Re: Bayer MaterialScience LLC
125 New South Road – Hicksville, New York
ICM Work Plan Modification
USEPA ID#: NYD002920312
BBL Project #: 2302.32303 #5

On behalf of Bayer MaterialScience LLC (Bayer), this letter modifies the *Interim Corrective Measure Work Plan* (the ICM Work Plan) prepared by Blasland, Bouck & Lee, Inc. (BBL, June 2004) for the Bayer site located in Hicksville, New York. The modification is being submitted in response to the New York State Department of Environmental Conservation's (NYSDEC's) comments included with your e-mail correspondence dated April 25, 2005. For ease of presentation, each NYSDEC comment is presented below, followed by Bayer's response.

REPORT

*Interim Corrective Measure
Work Plan*

FIGURE
4

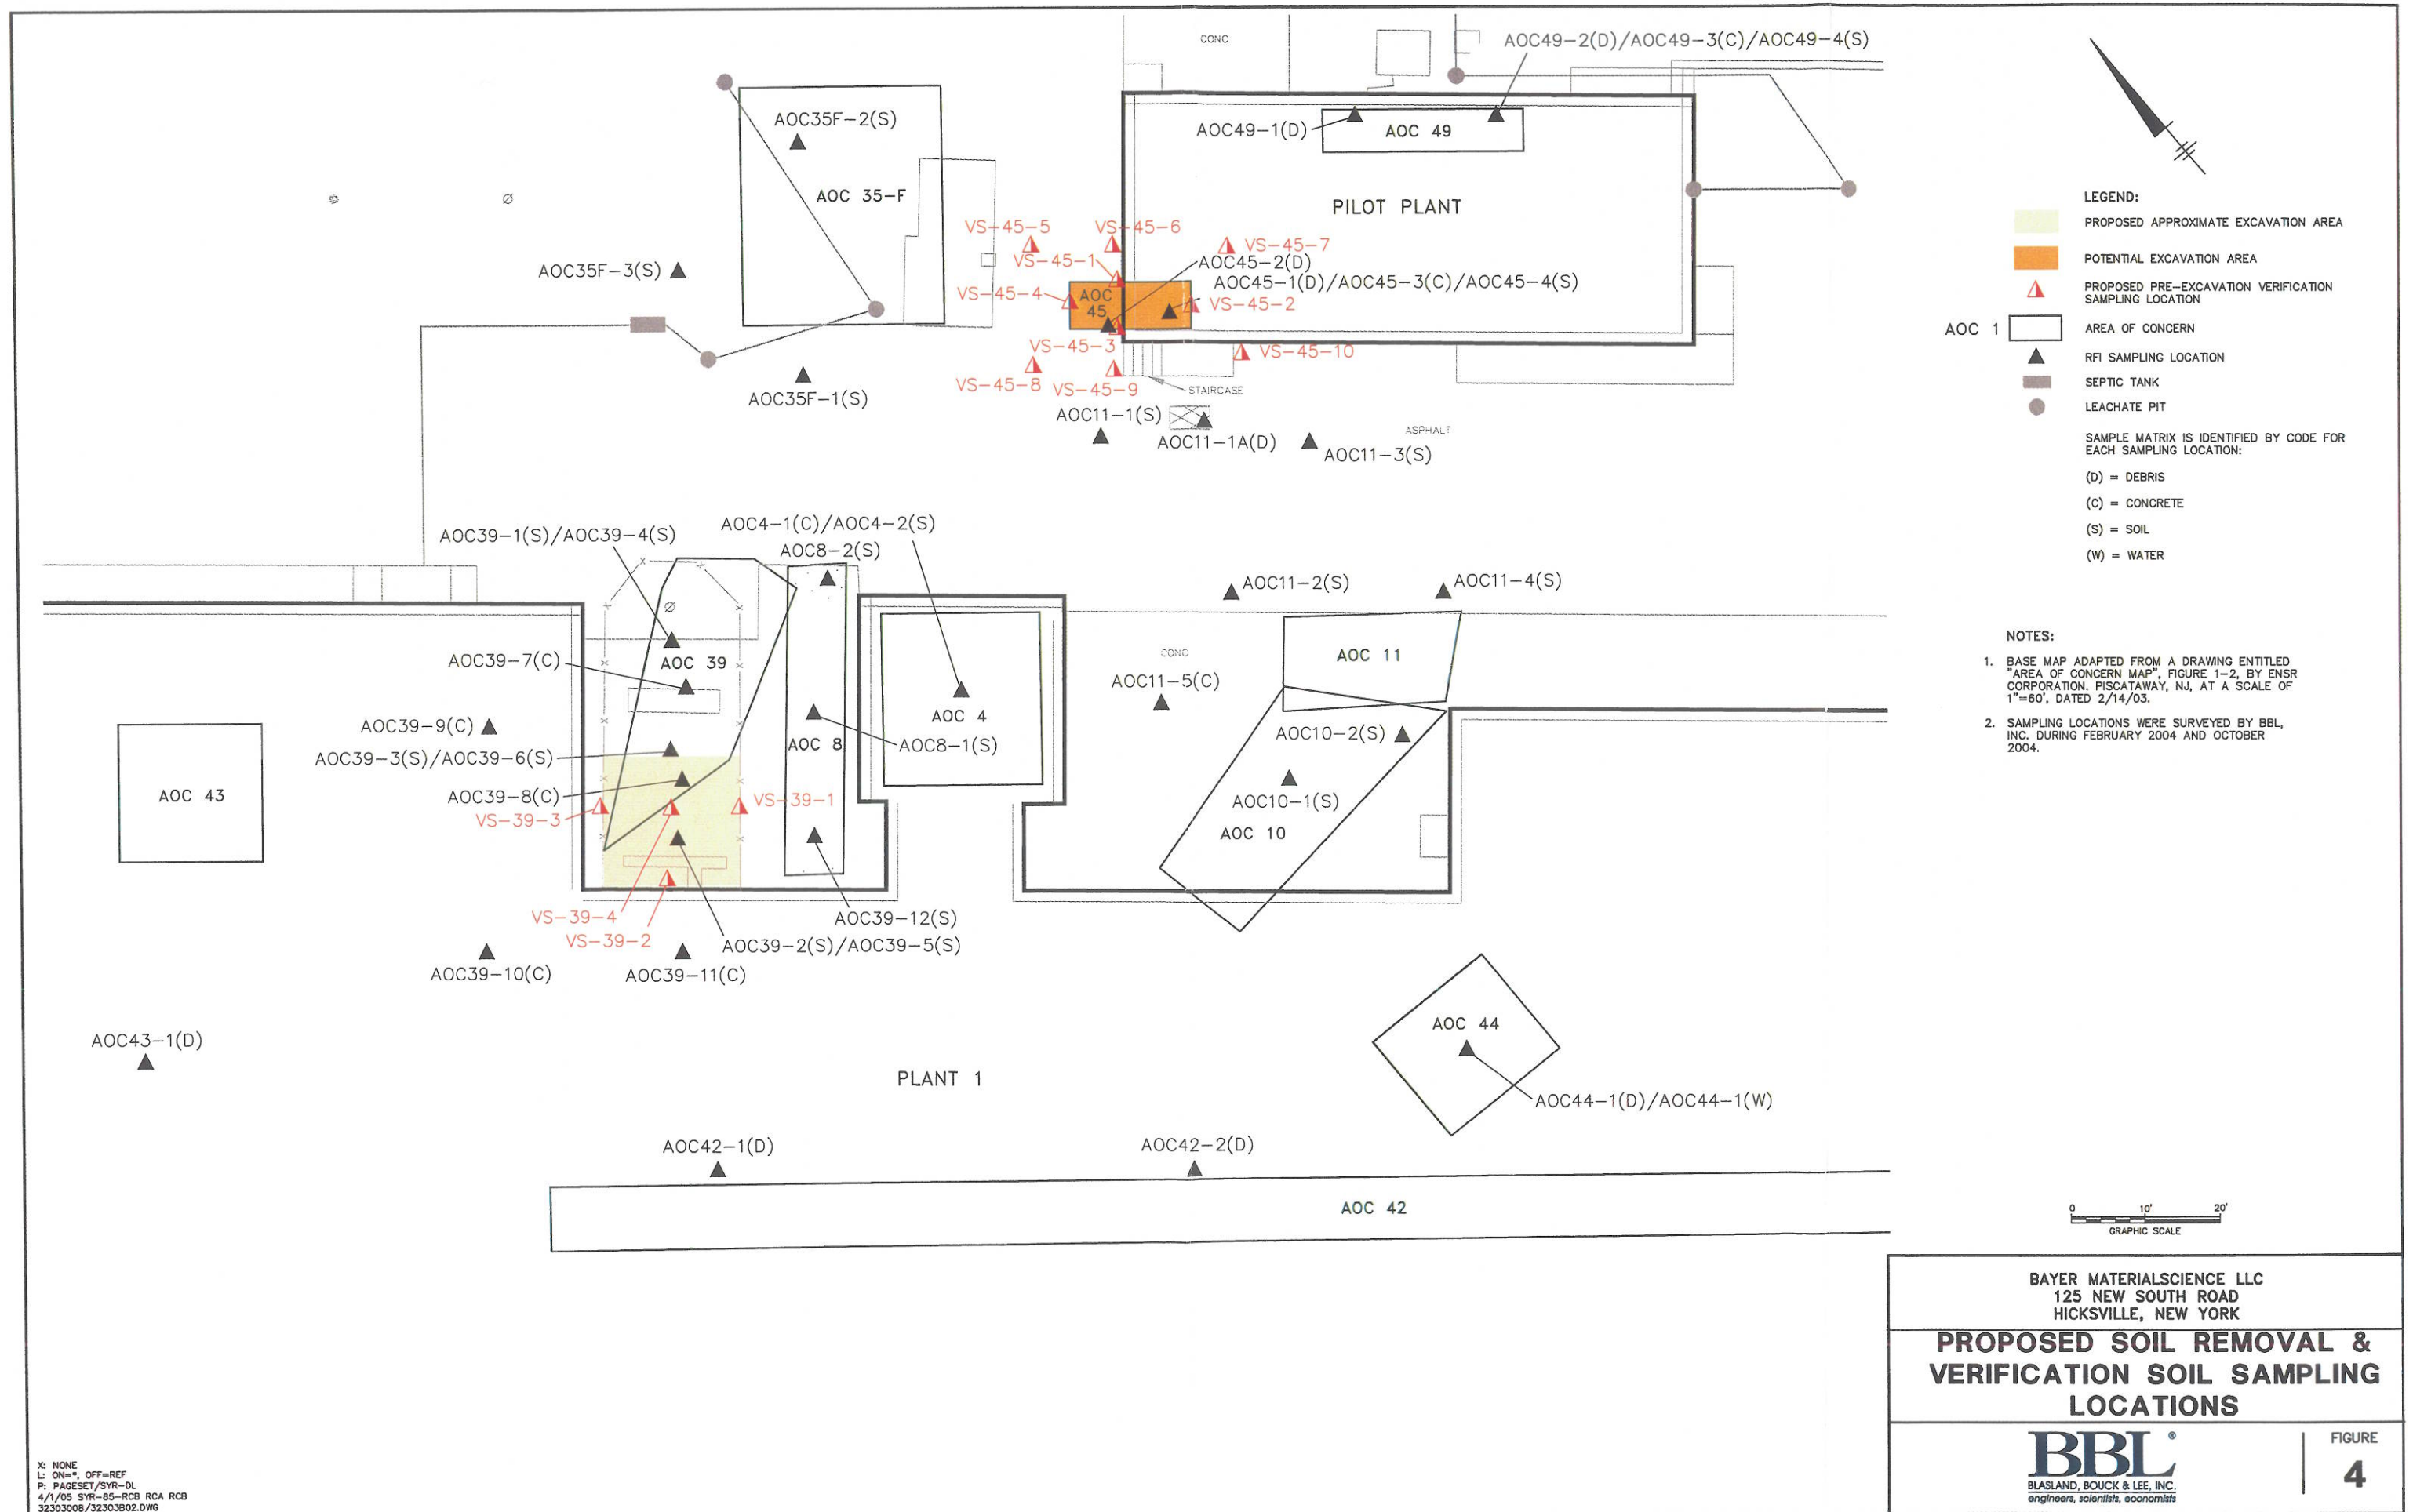
Comment 9

It is not clear why the sidewall samples will be discrete and the bottom samples will be composited. Also explain the logic for collecting a sidewall sample from the 0-2 inch depth interval. This interval seems insufficient for a deep excavation. [See comments above for section 2.2.2.]

Each post-excavation verification soil sample from AOC 39 (if any) will be a discrete sample collected from soils encountered beyond any "heavy staining". Based on the laboratory analytical results obtained for the RCRA Facility Investigation (RFI) soil samples, the excavation within AOC 39 is anticipated to be shallow, extending approximately 2 feet below the ground surface. The sidewall samples will be collected from the same depth where the staining was encountered (the 0 to 2-inch if the staining were to be found at, or immediately below the ground surface, or an appropriate 1-foot depth interval if the

staining were to be found below a depth of 2-inches). The bottom sample(s) will be collected over a 1-foot increment from the soils remaining below the staining.

The same approach would be used for AOC 45 (Sump at the Northwest Corner of the Pilot Plant) if it is determined that soil removal will be performed in this AOC. The NYSDEC will be contacted to discuss sampling intervals in the event that heavy staining is encountered in either AOC 39 or AOC 45.
